FINAL REPORT

**INDEPENDENT TECHNICAL REVIEW OF
N SPRINGS EXPEDITED RESPONSE ACTION PROPOSAL
HANFORD SITE**

**ADVANCED
SCIENCES, INC.**

FEBRUARY 22, 1994-

FIGURE 1
 TYPICAL VERTICAL BARRIER LOCATIONS

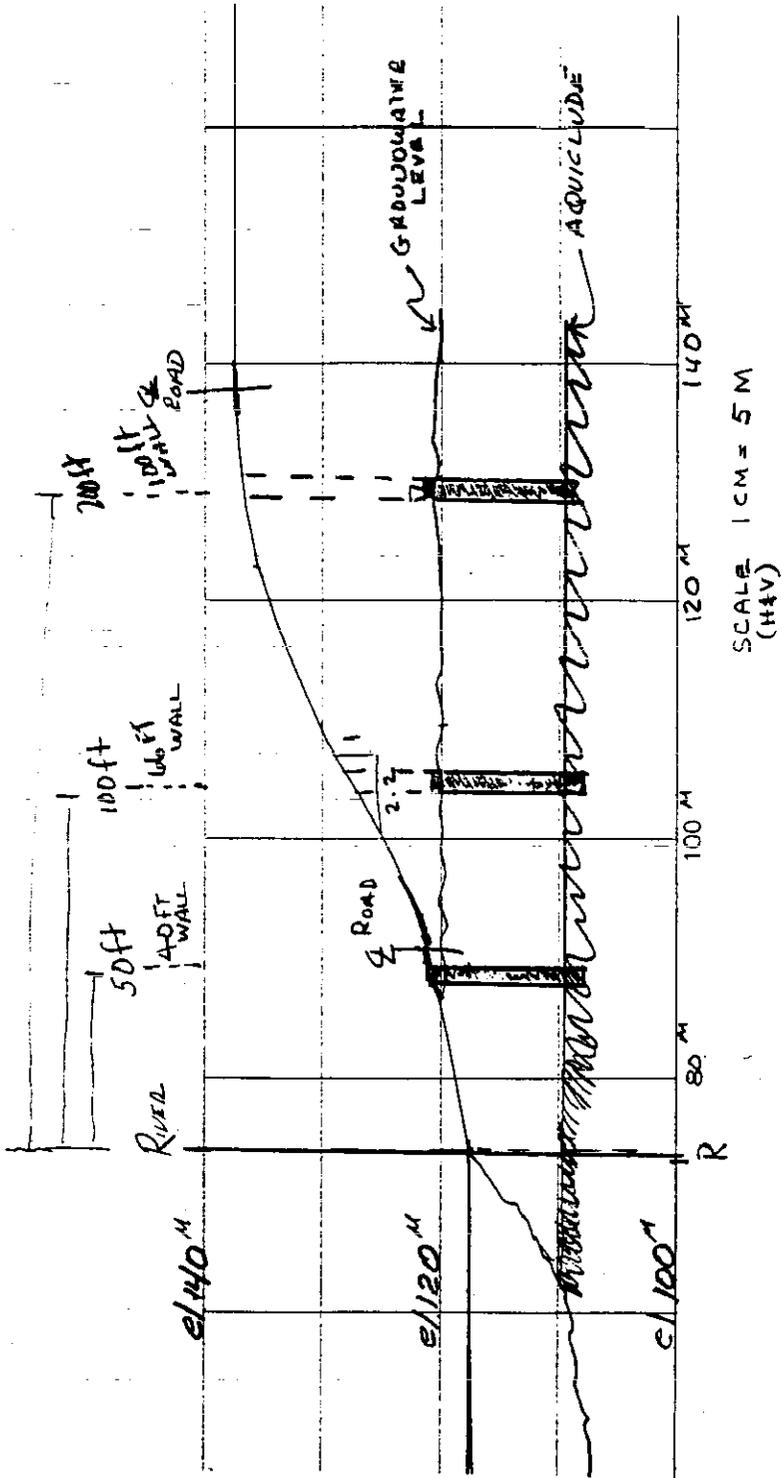
The location and alignment of the proposed vertical barrier wall system does not seem to be well engineered. In reviewing the available topography along the proposed general alignment, several issues were identified (see Figure 1): 1) the wall must be about 200 feet from the river to reach the near-level (elevation 135 to elevation 140) highlands above the river, at this location the required depth of a barrier wall will be about 100 feet; 2) at 100 feet from the river the barrier wall is located on a slope typically ranging from 2 horz. to 1 to 3 horz. to 1 and the required depth of the wall ranges from 60 feet to 80 feet; and 3) at 50 feet from the river the barrier wall is located on the same slope (in some locations on or near an access road) and the required depth of the wall ranges from 40 feet to 50 feet. The depths for a wall 50 feet and 100
